SUB-COMMITTEE ON SHIP SYSTEMS AND EQUIPMENT 10th session Agenda item 17

SSE 10/17/3 24 November 2023 Original: ENGLISH Pre-session public release: ⊠

# **BIENNIAL STATUS REPORT AND PROVISIONAL AGENDA FOR SSE 11**

Proposal to include the output "Development of amendments to chapter 15 of the FSS Code on enclosed spaces containing a nitrogen receiver or a buffer tank of nitrogen generator system" in the provisional agenda of SSE 11

#### "2.2.6 Installation on board

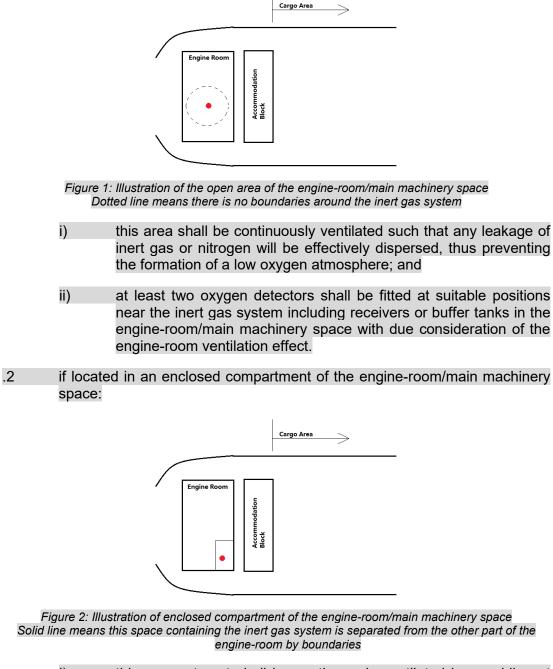
2.2.6.1 A flue gas or inert gas generator shall be located outside and aft of the cargo area, while a nitrogen generator, the nitrogen receiver or a buffer tank may be located in the cargo area.

2.2.6.2 The vent outlets and relief valve outlets from the inert gas generator, nitrogen generator, the receiver or buffer tank shall lead to open deck at a safe location and be arranged at least [3 m] from all openings leading to accommodation, service or control station spaces, and any other space/compartment where crews are supposed to work in or access regularly."
